Subject: Development Application (DA2023/0951) lodged by Royal Motor Yacht Club

(RMYC), 46 Prince Alfred Parade, Newport.

I am writing about the Development Application (DA2023/0951) lodged by Royal Motor Yacht Club (RMYC), 46 Prince Alfred Parade, Newport.

1. Removal of the existing Lift and Lift Shaft and replacement with a modern unit.

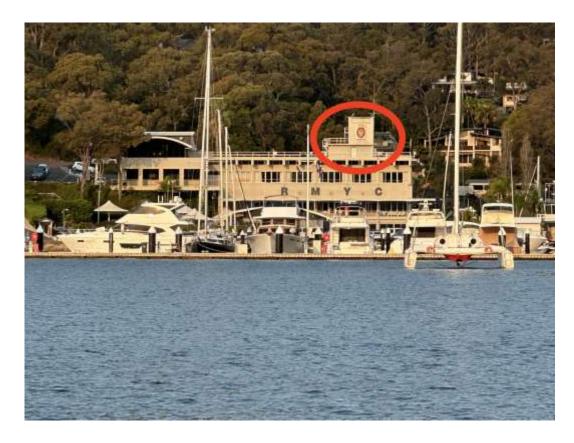
- It be assessed against the requirements with relation to the impacts upon the visual and scenic qualities for the foreshore area and consideration the surrounding coastal and built environment, and the bulk, scale and size of the proposed development.
- Development shall minimise any visual impact on the natural environment when viewed from any waterway, road or public reserve
- the 8.5m maximum building height.
- The Lift Shaft built in the 1960s in anyone's eyes is truly an eyesore. A carbuncle on the shores of Pittwater.

- Both the NBC and RMYC have highlighted that the current Lift Shaft is 4m above the permissible building height at 12.5 meters.
- This is a non-compliance of 47%.

- This was a discussion point during the meeting with residents. The CEO stating the only reason it could not be replaced with a new lift was money.
- Note in this new development the RMYC will be installing a new lift closer to the main entrance of the club – so why not install two new lifts – new technology would then enable the existing 4 meter non-complaince to be removed – beautifying Pittwater for all!

- As touched on earlier, NBC states in the Pre-Lodgment Meeting "The proposal must consist of a high quality built form and demonstrate a visual improvement to the foreshore character" Removing the lift shaft is the perfect opportunity. If the club's budget has not allowed for modernizing the existing lift, to complement the other works proposed, then do away with the outmoded lift and demolish the offending tower.
